Keep Our Meadow Green  
Residents Committee

**Re planning application 65439/VAR - Meadow Lane  
Response to AECOM Design Team and Knights**

**Figure 2.3: Typical Junction Flow / Delay Relationship Graph**

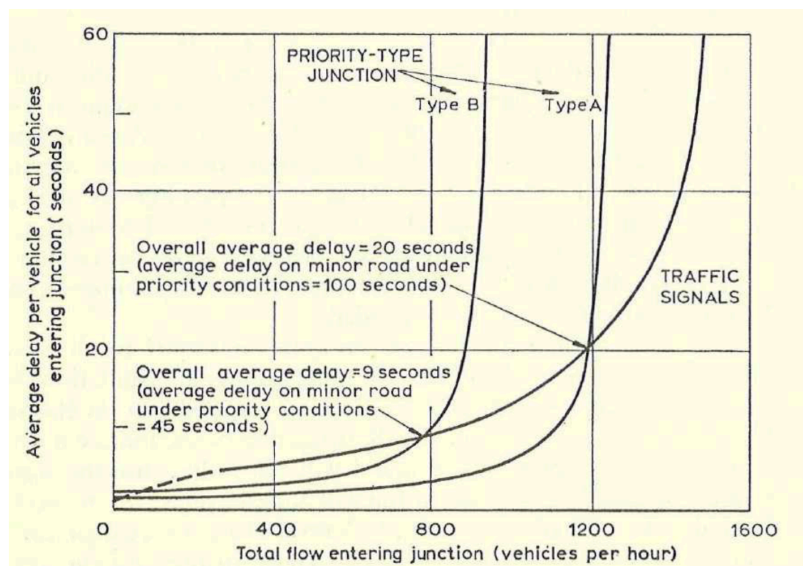
The extract below is taken from the ARUP Welsh Govt Local Model Validation Report, it clearly shows the relationship between delay and flow is not constant (either at priority or signalised junctions – in fact it applies at any type and size of junction)

For queuing and journey time validation, it is relevant that the junctions in the study area are generally operating under congested conditions in the AM and PM peak periods. When a junction reaches 90-100% capacity, queues and delay grow exponentially, and hence validating to an exact queue length or journey time is not realistic. The diagram in Figure 2.3 (which is an extract from Webster and Cobbe, 'Traffic Signals', Road Research Technical Paper 56) shows the typical relationship between flows and delays at busy junctions. For example, the

diagram indicates that for a give-way junction at or near saturation, a 5% increase in traffic can engender a 200% increase in delay, and for a traffic signal junction, a 5% increase in traffic can result in a 50% increase in delay. Therefore, for validation of the relatively small network in this case, the approach to validating queues is based on achieving a good fit to the observed range of queue lengths i.e. 'short' queues of up to 20 vehicles, 'medium' queues of around 20-40 vehicles, or 'long' queues at around 50 (or over) vehicles.
